Service Information No. 130
Kundendienst-Mitteilung No.
Service Information No.
Información de servicio No.
Servicemeddelelse No.

Date / Datum / Date / Fecha / Dato October 1989

Regarding Uptuning Problems with SAILOR Programme 1000/B Short Wave Transmitter T1130/T1135

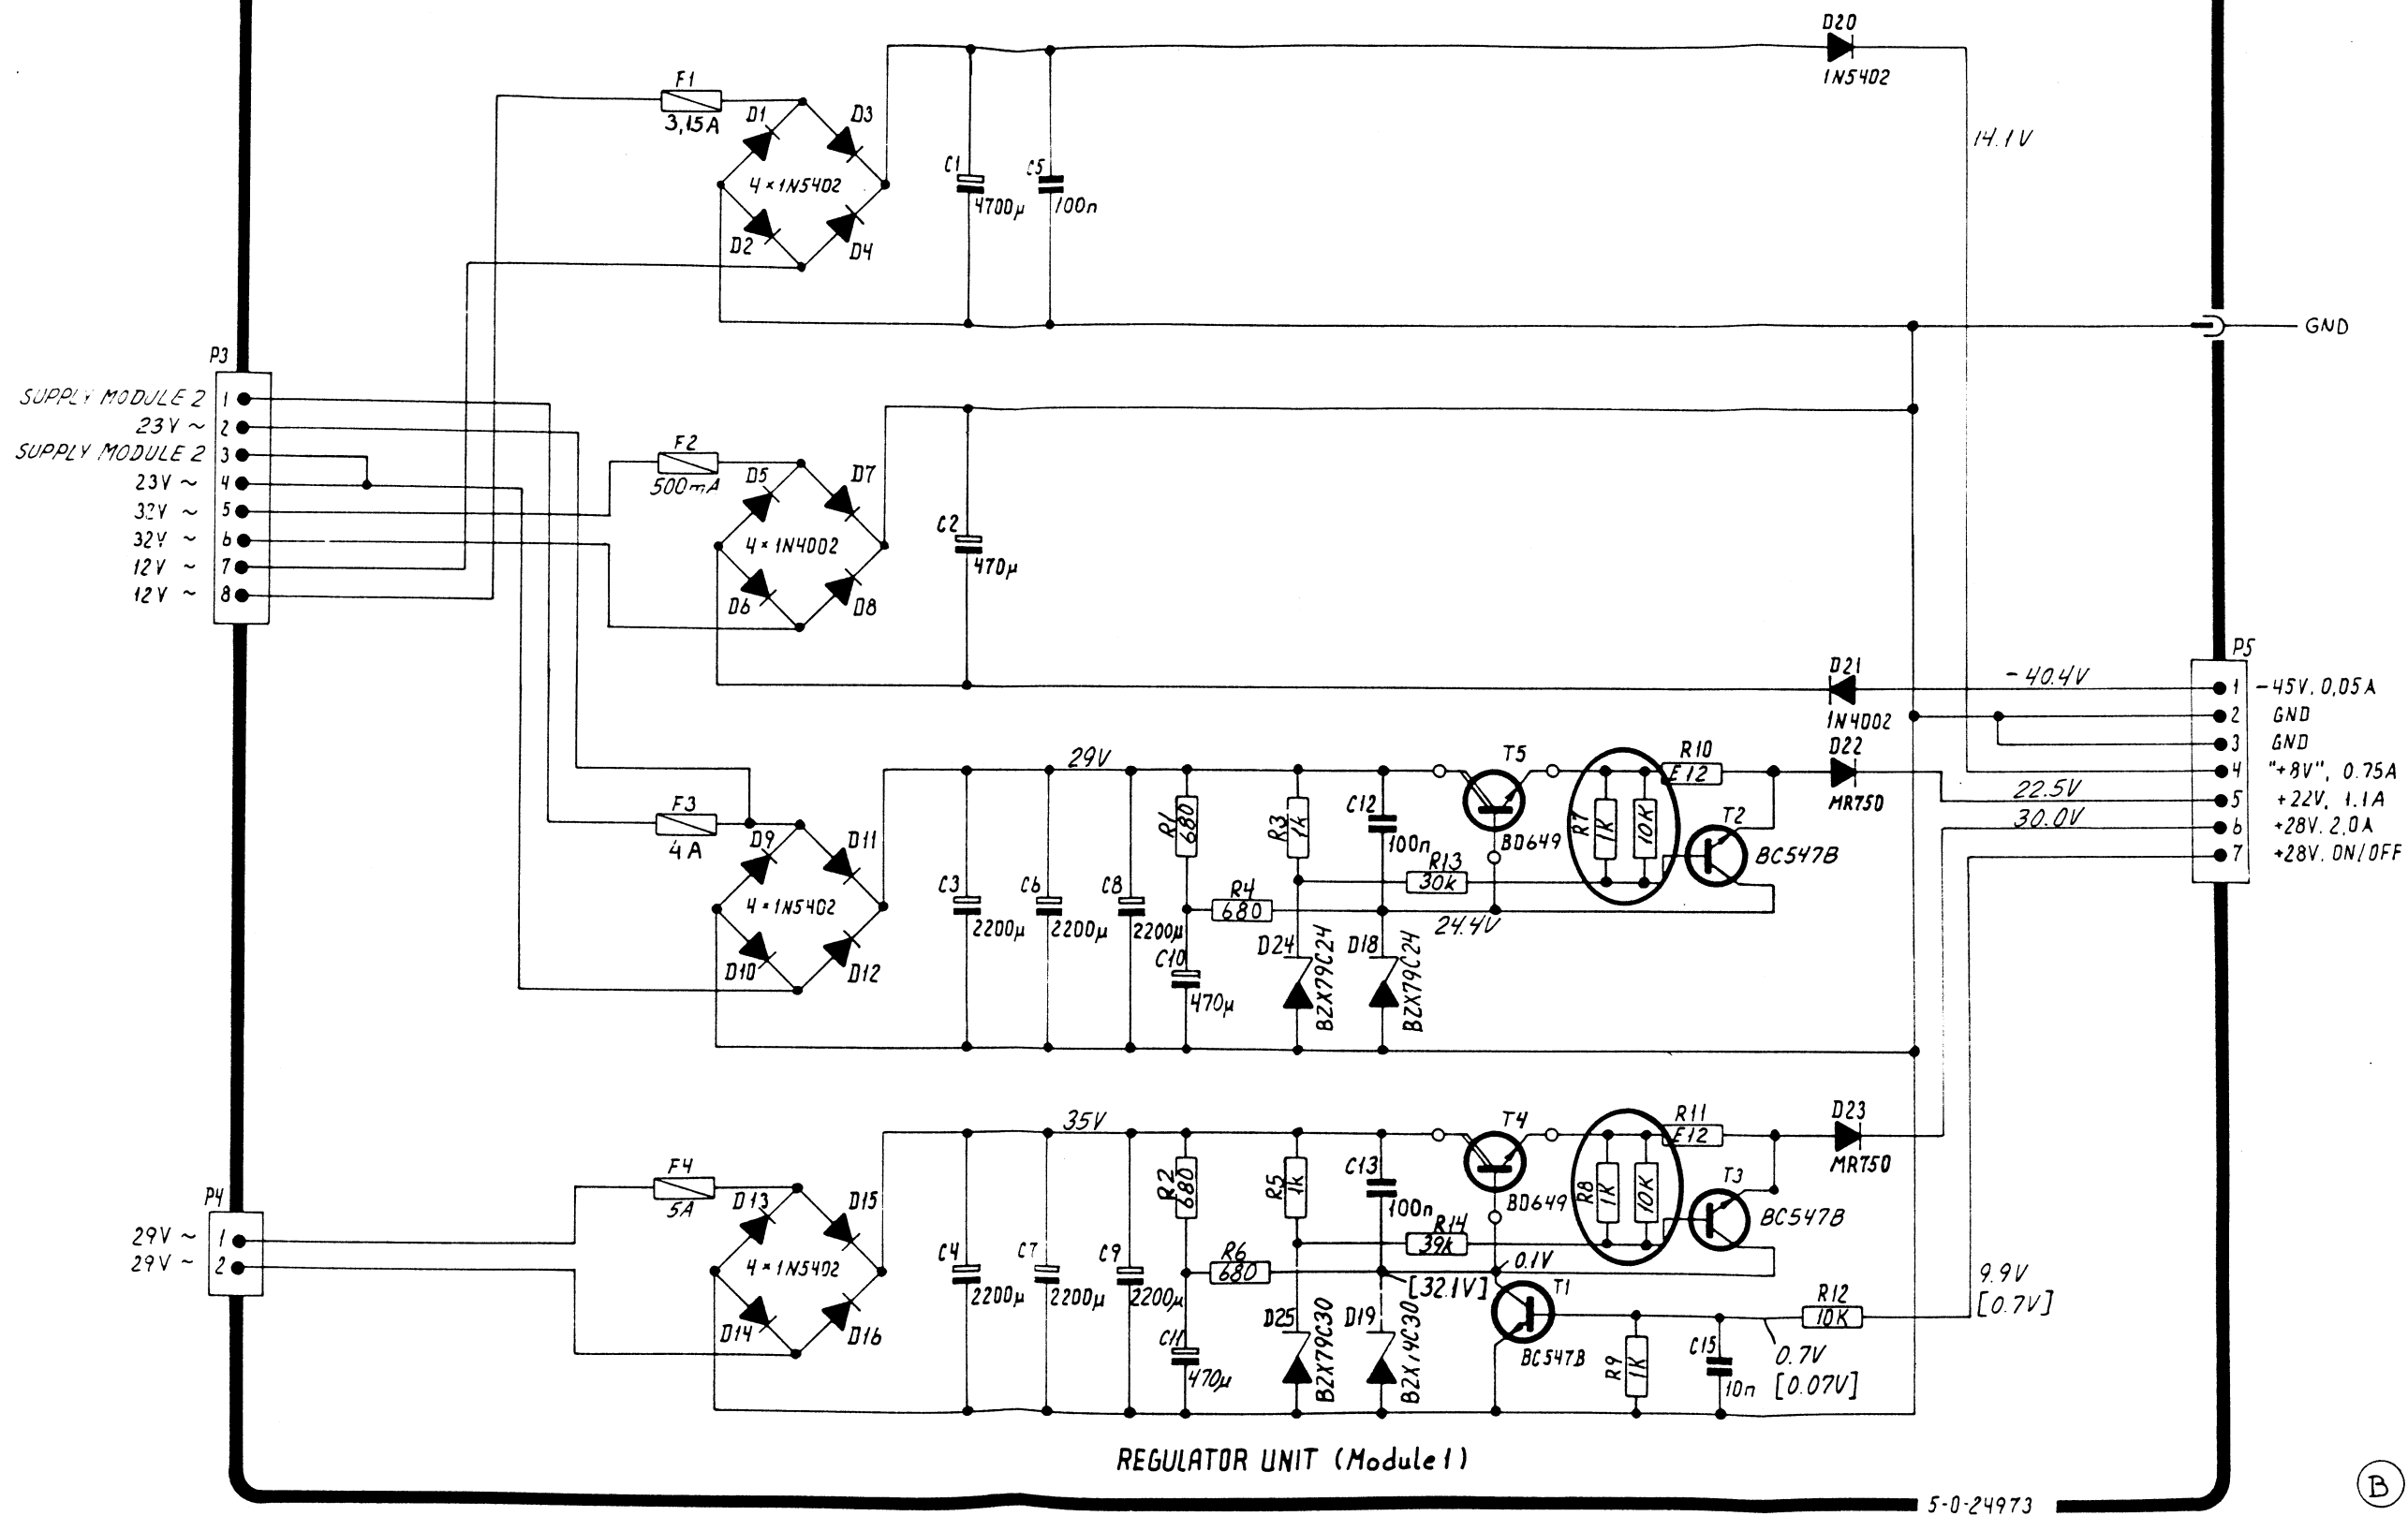
You may run into problems with some transmitters in connection with uptuning when the VSWR-condition is worse than 1.4.

The reason is that the Invalid Tuning button (S304 in T1130/T1135) is activated when the air filter is mounted.

The problem can be solved by a halving of the filter mat in front of the button.
